**PLANNED UNIT DEVELOPMENT &
SUBDIVISION STAFF REPORT**

Date: February 17, 2005

DEVELOPMENT NAME Rochester Place Subdivision, Revised Plat of

SITE PLAN

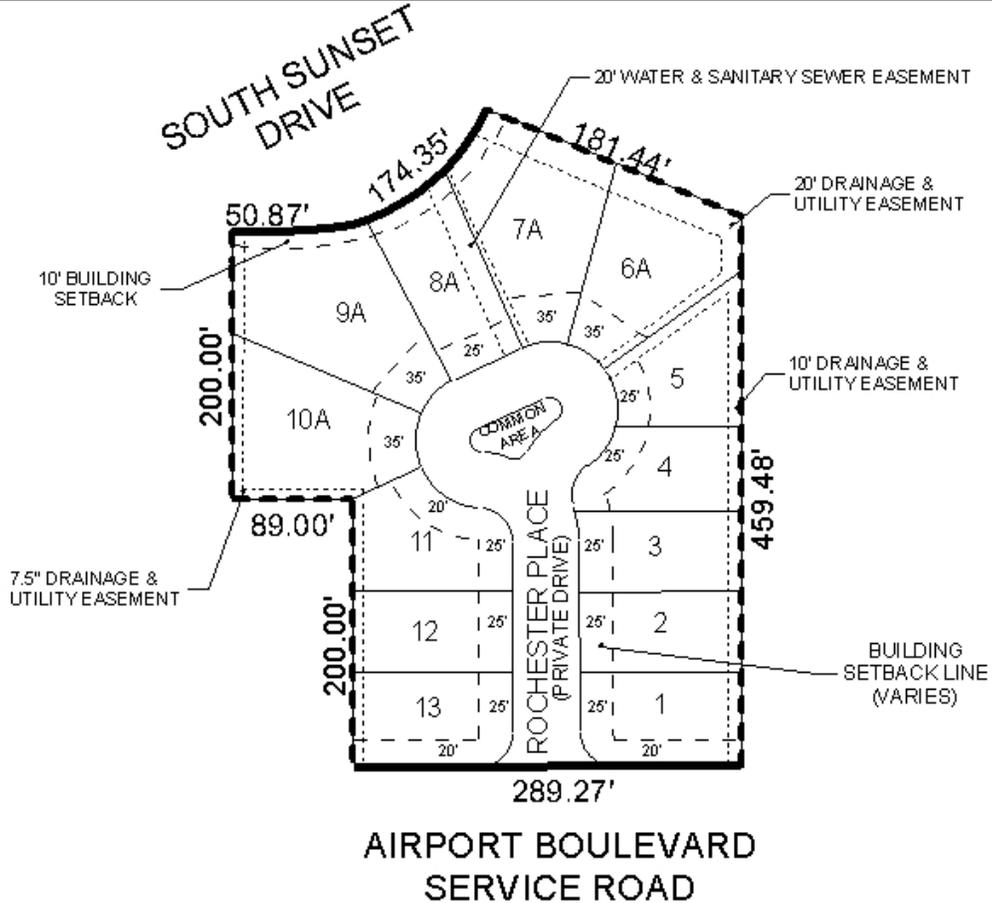
The rear of lots 7A-9A have frontage on both Rochester Place and South Sunset Drive. The previous application illustrated a 25-foot wide buffer and common area along South Sunset Drive. The applicant now proposes a 10-foot building setback along South Sunset Drive, and residential lots fronting two streets typically provide only an eight foot setback from the rear street property line. Additionally, buffers are rarely (if ever) required by the Commission to screen R-1 property from R-1 development. However, to restrict access to the private street, a note should be placed on the final plat stating that the site is denied direct access to Sunset Drive South.

Planned Unit Development Based upon the preceding, this application is recommended for approval subject to the following conditions: 1) compliance with the landscaping and tree planting requirements of the Ordinance; 2) placement of a note on the final plat stating that if the gate ceases to operate, the road must be dedicated to the City; 3) preservation of 53" Oak (any work on or under this tree is to be permitted and coordinated with Urban Forestry; removal to be permitted only in the case of disease or impending danger), as well as protection status for any existing trees that are located within the existing right-of-way (permits required from the Urban Forester for trimming or removal); and 4) denial of direct access to Sunset Drive South.

Subdivision The plat meets the minimum requirements of the Subdivision Regulations and is recommended for Tentative Approval subject to the following conditions: 1) compliance with the landscaping and tree planting requirements of the Ordinance; 2) placement of a note on the final plat stating that if the gate ceases to operate, the road must be dedicated to the City; 3) preservation of 53" Oak (any work on or under this tree is to be permitted and coordinated with Urban Forestry; removal to be permitted only in the case of disease or impending danger), as well as protection status for any existing trees that are located within the existing right-of-way (permits required from the Urban Forester for trimming or removal); and 4) placement of a note on the final plat stating that the site is denied direct access to Sunset Drive South.
